Soil Investigation Part B Work Plan

**PG&E Topock Compressor Station,
Needles, California**

Prepared for
**California Environmental Protection Agency,
Department of Toxic Substances Control
and
United States Department of the Interior**

September 2012

FIGURE 2
Decision 1 Rules
Data Quality Objectives - Part B Soil Investigation
PG&E Topock Compressor Station
Needles, California

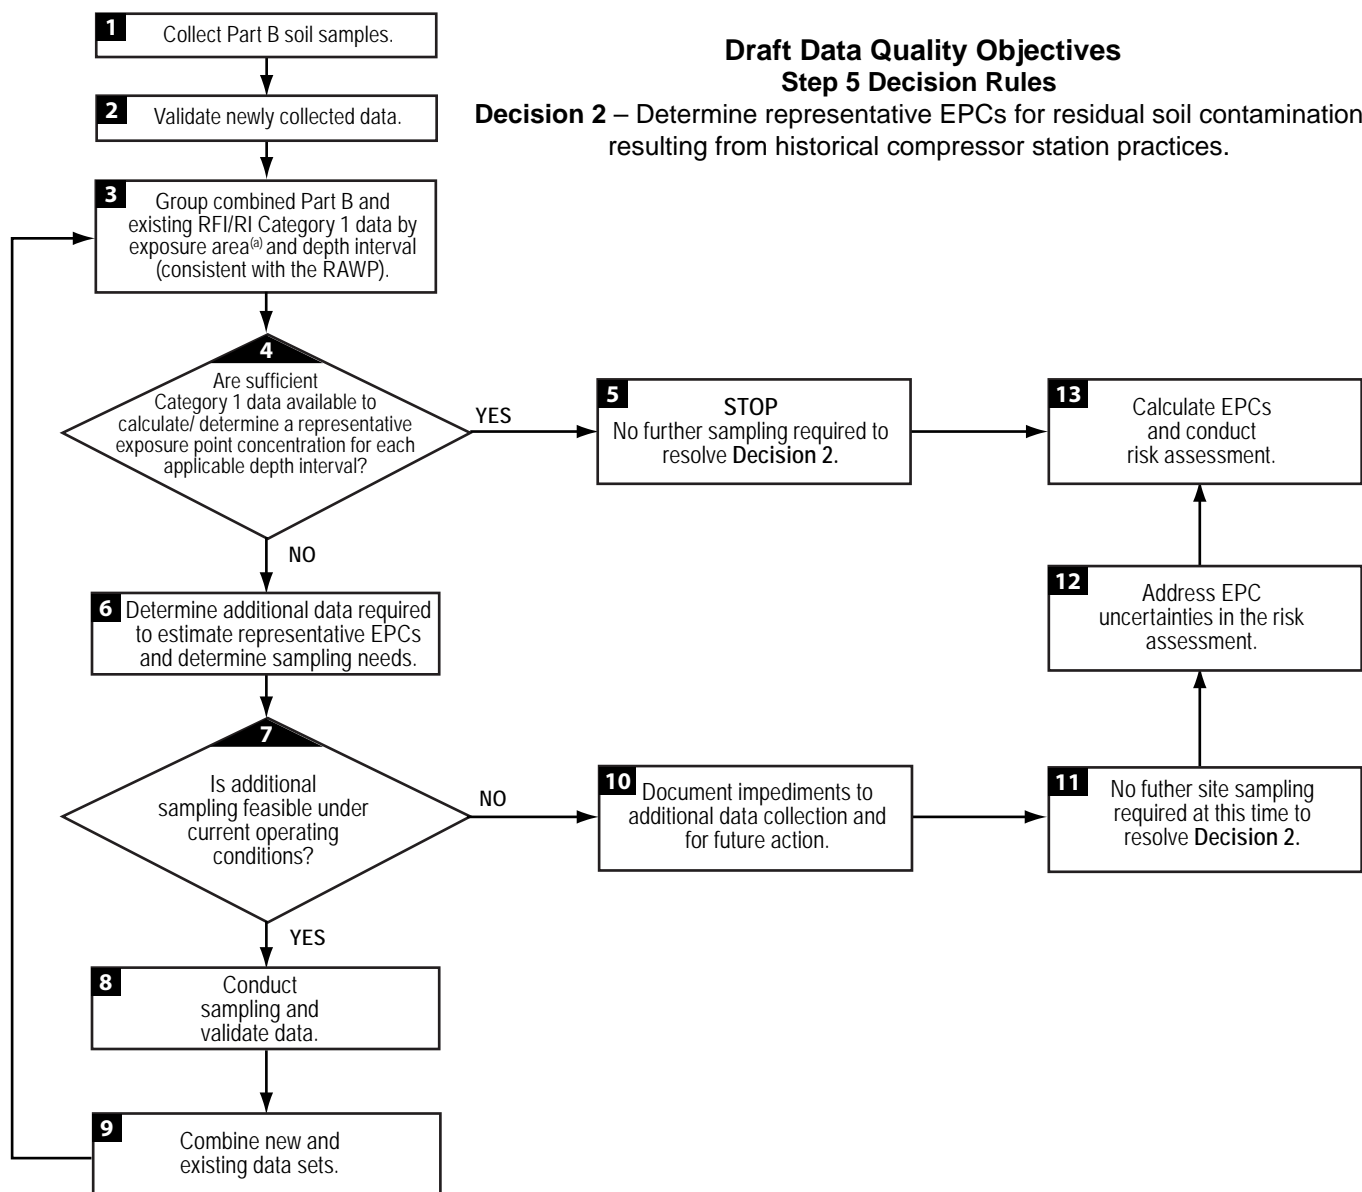
17	Figure 2, Page 44	M	The arrow from 5A connects to 5D (as it should) and also connects to the line from 5B. This is inconsistent with the if/then statements in the text. Also 5D should connect to 16A for consistency.	Box 5D should not have been shown as an endpoint. The “No” arrow from Box 5A will continue to connect to Box 5D, but will not connect directly to the “No” line between Box 5B and Box 5C. Instead, a line from Box 5D will lead to the “No” line between Box 5B and Box 5C. Box 5D is a reminder that any new COPCs without screening levels must be addressed in the RA and RFI/RI reports, and evaluation of the data set continues with Box 5C. Figure 2 for Decision 1 has been corrected as described.

FIGURE 6
Decision 5 Rules
Data Quality Objectives - Part B Soil Investigation
PG&E Topock Compressor Station
Needles, California

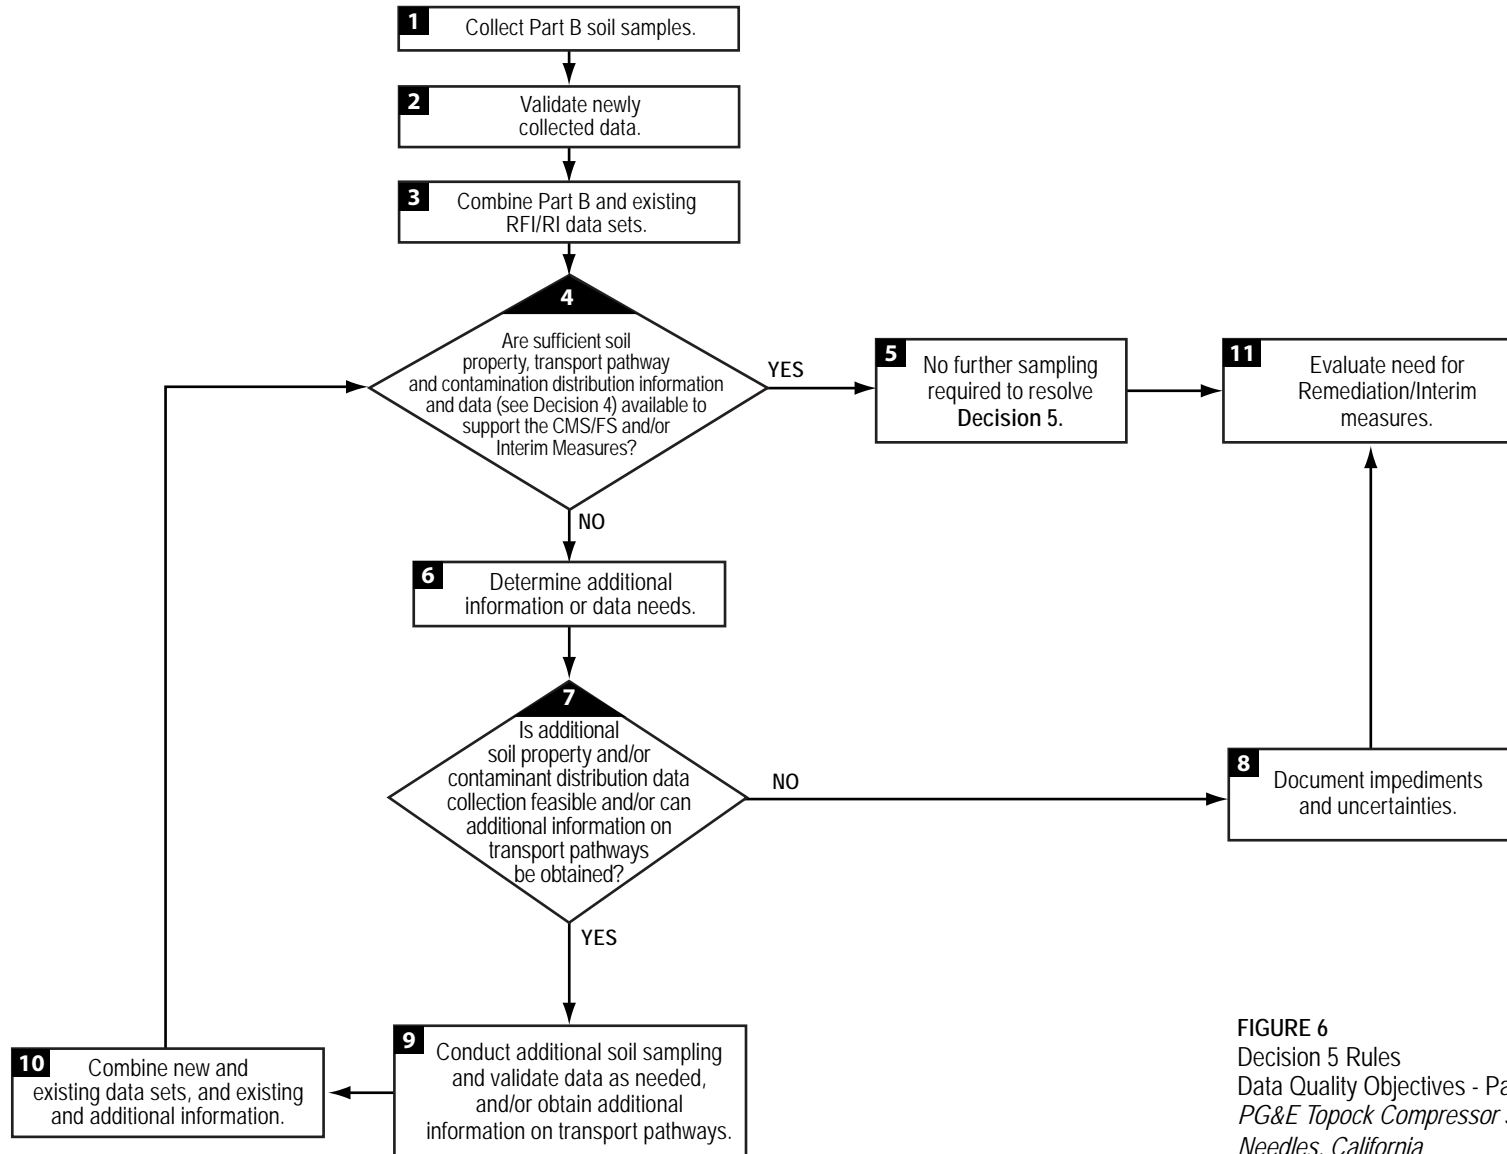
23.	Section 2.7.5.1. Page 30.	Box 4 (Figure 6) in Decision 5 states, “ <i>Is sufficient soil property, transport pathway, and contamination distribution information available to identify areas that may result in offsite migration concerns?</i> ” This inappropriately limits interim or remedial measures to those onsite Part B soils that could cause an offsite problem. As onsite problems (human health risk, potential to impact groundwater) must also be addressed, the section and Figure 6 will need to be modified. Box 4 should read as follows: “ <i>Is sufficient soil property, transport pathway, and contamination distribution information data available to identify areas that may result in offsite migration concerns support the CMS/FS or Interim Measures?</i> ”	Box 4 of Decision 5 was revised to read: “ <i>Is sufficient soil property, transport pathway, and contamination distribution information available to identify areas that may result in offsite migration <u>or excess onsite exposure</u> concerns?</i> ”	See DTSC’s response to Comment 5. Changes must be made to the document as originally requested in DTSC’s comment.	The text was modified as directed.

Comment Number	Section/ Page	DTSC Comment (February 8, 2011)	PG&E Response (February 25, 2011)		
1.	Figure 6, Sections 2.1.1 Section 2.7.5.1 Section 2.7.5.2	<p>Box 11 of Figure 6 should be updated to be consistent with the CMS/FS/interim measures text changes previously incorporated into the document. The following language is suggested for Box 11: "Evaluate need for potential migration and exposure control remediation / interim measures.</p> <p>Related text in Sections 2.1.1 (page 4, paragraph 3, last sentence) - Section 2.7.5.1 (page 31, Yes response, last sentence mentioning Box 11), and Section 2.7.5.2 (page 31, last paragraph, last sentence), should be updated in a similar manner.</p> <p>Please review the entire document and revise all relevant sections, for consistency with the changes identified above.</p>	The text was modified as directed.

FIGURE 7
PRELIMINARY HUMAN HEALTH CSM FOR INSIDE THE COMPRESSOR STATION
PACIFIC GAS AND ELECTRIC COMPANY
DATA QUALITY OBJECTIVES - PART B SOIL INVESTIGATION

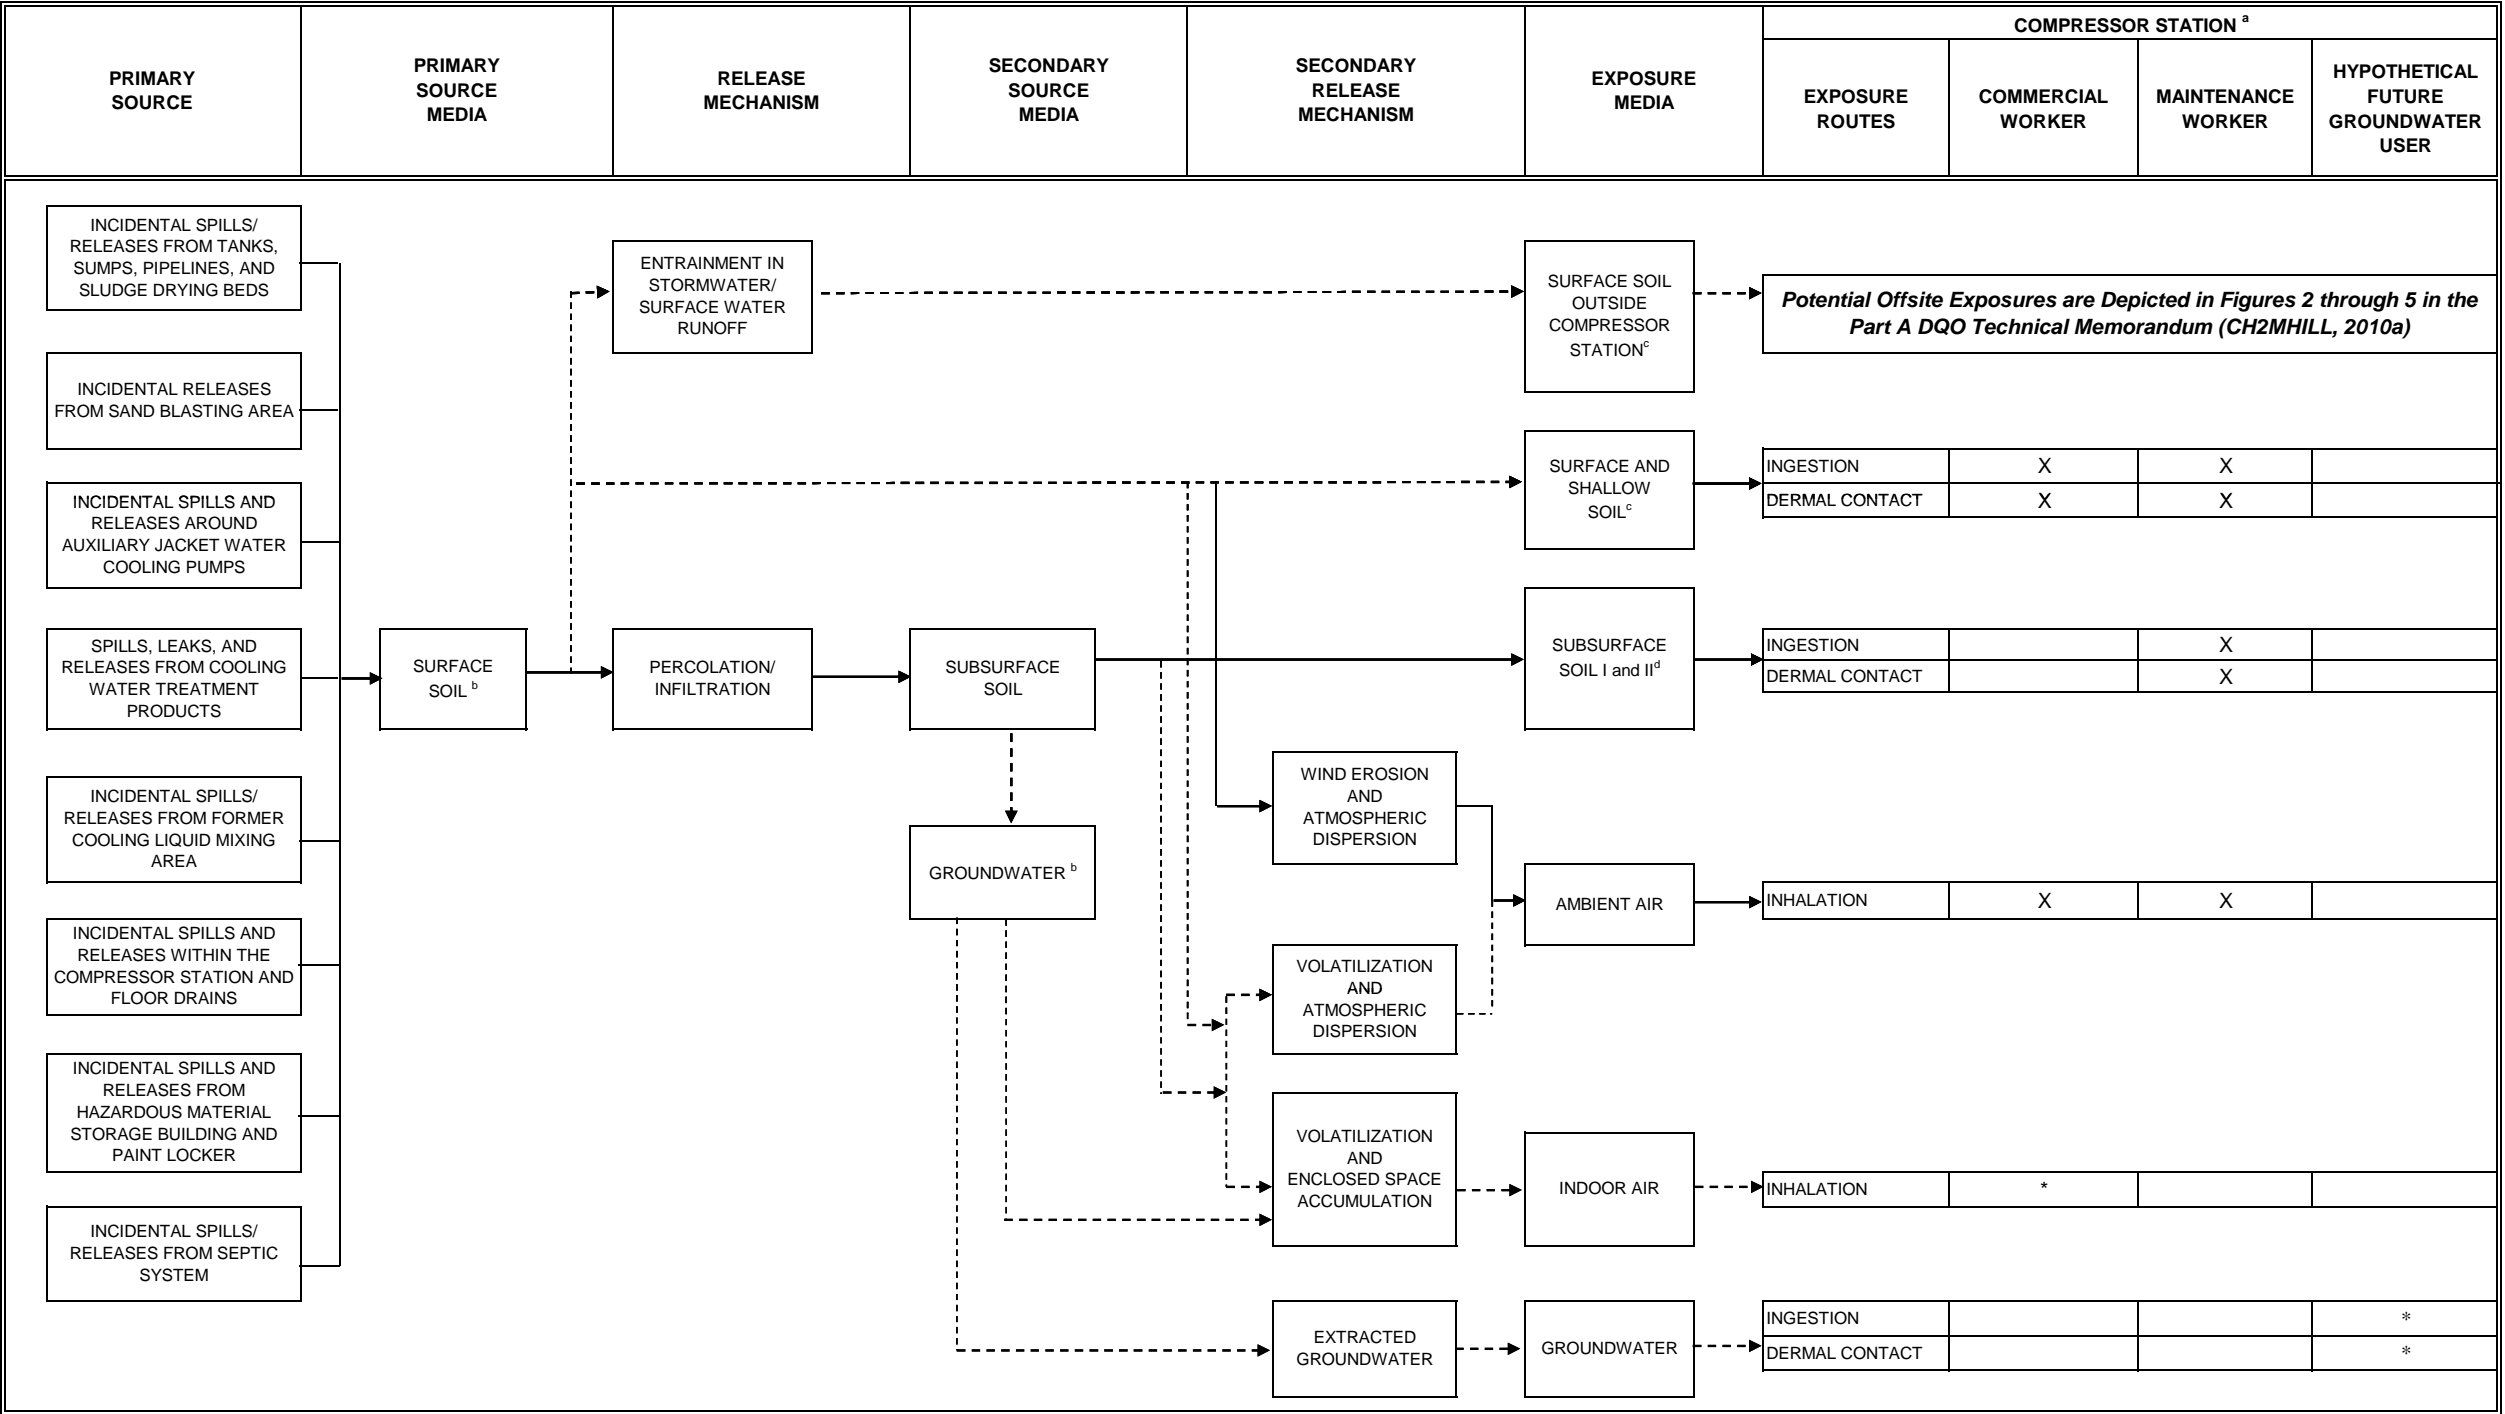
24.	Figure 7.	Releases from the cooling towers (Primary Source column) should also be documented as occurring as mists/drift that would have coated soils, concrete, and building surfaces. The figure identifies storm water/surface water runoff as a potentially complete pathway. Therefore, PG&E is directed to establish a site-wide storm water monitoring program to assess potential impacts from the facility to offsite receptors.	Release of mist/drift is an incidental spill/release from the cooling towers, and is addressed in the CSM. Other incidental spills/releases may also have contacted buildings, concrete pads or other structures in addition to soils. Any deposits on outdoor surfaces may then result in secondary release to surface soil The request for a storm water monitoring program requires further discussion between PG&E and DTSC, and is not related to the Part B DQO TM.	See DTSC’s response to Comment 7 regarding releases to concrete and buildings. PG&E should add the establishment of a storm water monitoring program to the rainbow schedule. This program will ensure that current PG&E operations are not adversely affecting site conditions.	Please see PG&E’s response to DTSC’s Comment 7. As directed by DTSC, PGE will conduct storm drain monitoring, however, due to the location of storm drains primarily along the steep slopes of the facility perimeter, the highly sporadic nature of rainfall in this area, as well as significant safety issues, traditional storm water monitoring is anticipated to be both spatially and temporally

6	Section 2.1.4, Page 6, 2 nd Paragraph, 3 rd sentence Figure 7, Page 49	M	This paragraph characterizes the surface soil interval as deep as 3 feet; however Figure 7 and Section 2.1.7 specify that the surface interval is 0-6 inches. Soil extending from 0 to 3 feet is specified as shallow soil. Revise 3 rd sentence to say “Commercial workers would be expected potentially to come into contact with surface <u>and shallow</u> soil in the 0-to-3-foot-depth interval.”	The text has been revised as requested.	
7	Section 2.1.6, Page 7	S	It may be appropriate to note potential sources of recharge within the compressor station area, including meteoric water.	The text and Table 1 have been revised as requested.	
8	Section 2.1.7, Page 7	M	For clarification, distinguish the difference between subsurface soil I and subsurface soil II. Section 2.1.4 discussions do not include the 0-6’ interval although all intervals are discussed in the RAWP. Please ensure consistency with the RAWP.	Comment noted. The text has been edited in Section 2.1.4 to include the 0-to-6-foot bgs interval for maintenance workers; subsurface soil I is defined as the 0-to-6-foot bgs interval, and subsurface soil II as the 0-to10-foot bgs interval.
